## MEMORANDUM

**SUBJECT:** The Concert Venues Building Proposed by Live Nation/Frank Productions Requires the City to Ignore the Carefully Constructed Zoning Commitments, Requirements and Goals for the Deer District

**DATE:** October 12, 2022

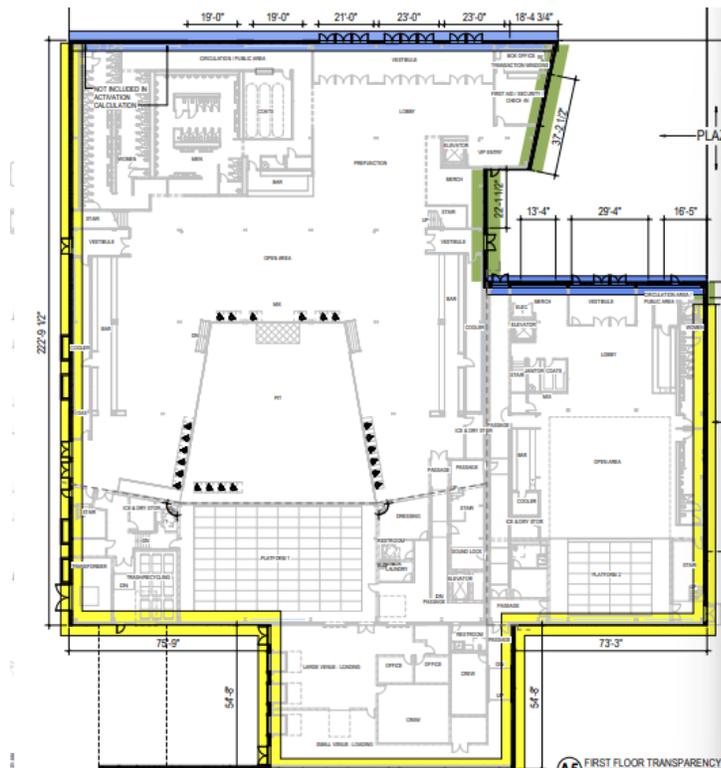
The proposed two-story building on Lot 2 will never happen or will not happen for many years. The developer knows that. That is why it plans to plant trees on the property.

- Similar promises were made for exceptions for the convention center. It took well over two decades for the promises to be fulfilled.
- The building would be between 9,000 and 10,000 square feet. Construction costs would be somewhere around \$2.5 million to \$3 million. No small user is going to pay that.

- The listing broker has made it clear that the current owners require that the property not be sold to a food or beverage user (the most likely small building users in this area). Here is what one broker was told by the listing broker:

**“No further food or liquor. ... The developer, the Bucks ownership, doesn’t want anything to compete with what they have going on so far.”**

That does not leave many real uses for this small building. Certainly not much that could afford the cost of standalone construction (and the special design to be “sympathetic” to Turner Hall).

**If the developer is certain that there will be a building on Lot 2, it could build it now.**
